LONDON TRANSPORT
OFFICE OF THE ENGINEERING SUPERINTENDENT (ROAD SERVICES)

G.S.I. 209 - ROUTEMASTER INSTRUCTION 96, SECTION 2.

RM GEARBOX - CURING THRUST PAD FOUL

This Instruction applies to all RM type gearboxes, unit codes GB.32 and GB.39.

FOULING OF THRUST PAD 2ND AND 3RD SPEED

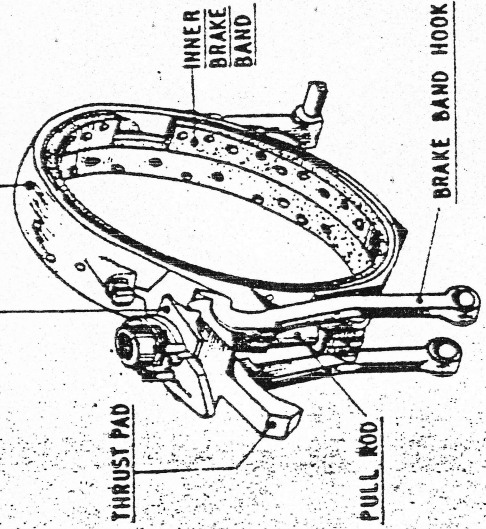
Examine the thrust pad flanks and if there is any sign of rubbing against the shoulders of the pivoted link then relieve the flanks of the thrust pad by grinding 45° chamfers to reduce or prevent the foul.

AREA OF FOUL
BETWEEN TAILPIECE OF
THRUST PAD & PIVOT LINK
